Synopsis

Application Request: Consideration and action on final approval of Fenster Farms Phase 4 Subdivision, a three-lot subdivision.
Type of Decision: Administrative
Agenda Date: Wednesday, February 24, 2021
Applicant: Kenny Palmer, Representative
File Number: LVF06012020

Exhibit A - Subdivision Plat

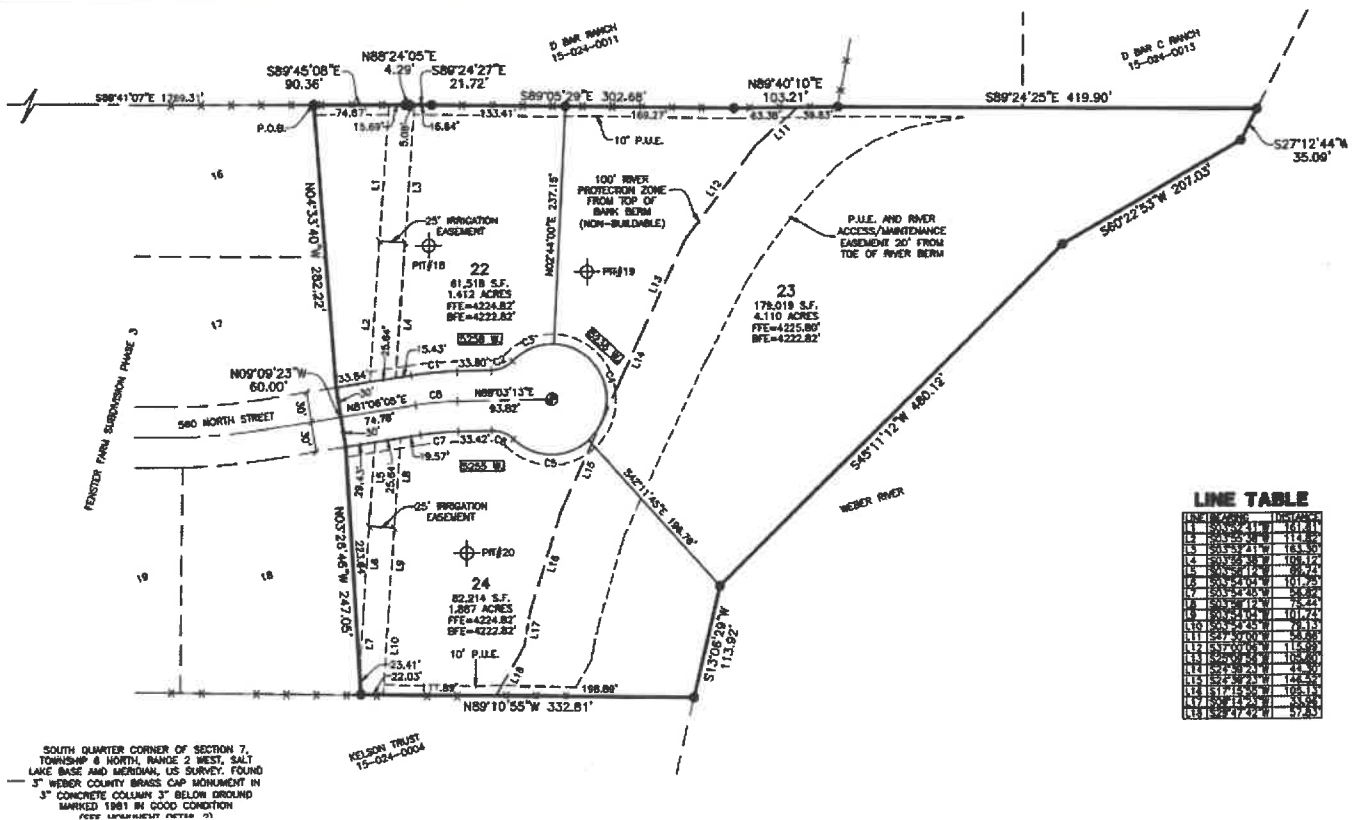
1. An escrow established for improvements to be installed, prior to recording the subdivision.
2. A 5' no-climb fence must be installed along both sides of the irrigation ditch to the west and south of the proposed subdivision.
3. Final approval from West Warren-Warren Improvement District must be obtained prior recording the subdivision plat.
4. A note shall be included on the final plat stating that no structures shall be constructed within any easements.
5. A 20' turnaround easement on the northern boundary and on the southern boundary, for the purposes of maintaining the ditch, shall be shown on the final plat.
6. A berm shall be shored up on either side of the irrigation ditch.
7. A gate shall be placed on the road sides of the ditch easement for maintenance access.
8. A 25' ditch easement shall be shown on the final plat.
